Access Compliance Report

Public Rights-of-Way

Intersection ID: N/A	Main Street: ALLISON_FOREST_TR	Cross Street: RUTAN_LN	Location: W
ADA ID: 9AF09A6B0EF2	Ramp Type: BlendTrans1	Initial Pass/Fail: Pass	Overall Compliance: No
			Severity Score: 0.25

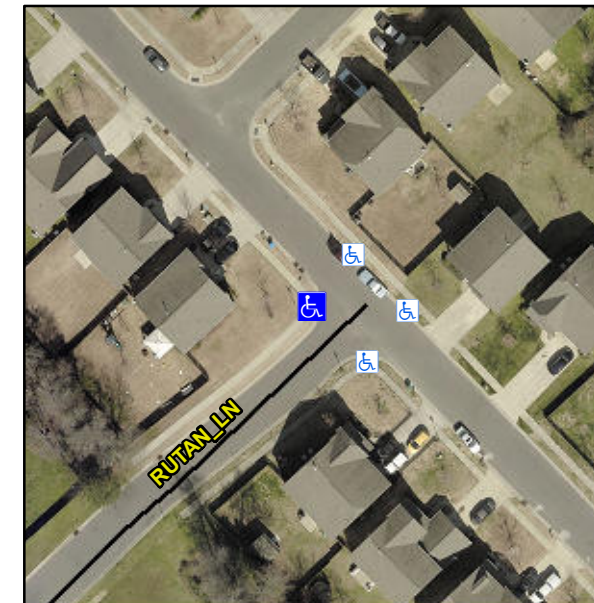
Not Found, R304.5.3, R304.2.1, R304.2.2-Perp, R304.3.2-Para, R305.2

Compliance	Description	Data	Compliance	Description	Data
N/A	Ramp Length (in)	46.5	Yes	BlendTrans Slope (%)	4.8
Yes	Ramp Width (in)	48.0	No	BlendTrans XSlope (%)	2.6
N/A	Flare Type LT	Sloped	N/A	Flare Type RT	Sloped
N/A	Flare Slope LT (%)	6.7	N/A	Flare Slope RT (%)	1.1
N/A	Flare Traversable LT?	No	N/A	Flare Traversable RT?	No
Yes	Landing Length (in)	50.0	Yes	DWS Provided?	Yes
No	Landing Width (in)	47.5	Yes	DWS Contrast?	Yes
No	Landing Slope (%)	2.6	Yes	DWS Length (in)	24.8
No	Landing X Slope (%)	4.7	Yes	DWS Full Width?	Yes
N/A	Landing Curb? (Y/N)	No	No	DWS Offset (in)	6.5
N/A	Shared Landing?	No			
Yes	Gutter Ponding?	No	Yes	Gutter Slope (%)	0.6
Yes	Gutter Lip Ht (in)	0.0	No	Gutter X Slope (%)	3.3
N/A	Painted X Walk1?	No	N/A	Painted X Walk2?	No
	X Walk 1 Direction	To SE		X Walk 2 Direction	To NE
	X Walk 1 Width (in)	N/A		X Walk 2 Width (in)	N/A
	X Walk 1 Slope (%)	2.8		X Walk 2 Slope (%)	1.7
	X Walk 1 X Slope (%)	3.1		X Walk 2 X Slope (%)	1.6

N/A	Ramp inside XWalk1?	N/A	N/A	Ramp inside XWalk2?	N/A
	Road Slope (%)	3.8		Clear Space?	Yes
	Road X Slope (%)	1.5	N/A	Clear Space to XWalk (in)	N/A
Yes	Any Obstructions?	No	Yes	Storm Grate/Utility Hazard?	No
	Obstruction Type			Storm Grate/Utility Type	
		N/A			N/A
			Yes	Surface Condition? (G/P)	Good
			No	Curb Slope (%)	12.0

Remove & Replace Curb Ramp With Two New Directional Ramps or Equivalent. Remove & Replace Gutter.
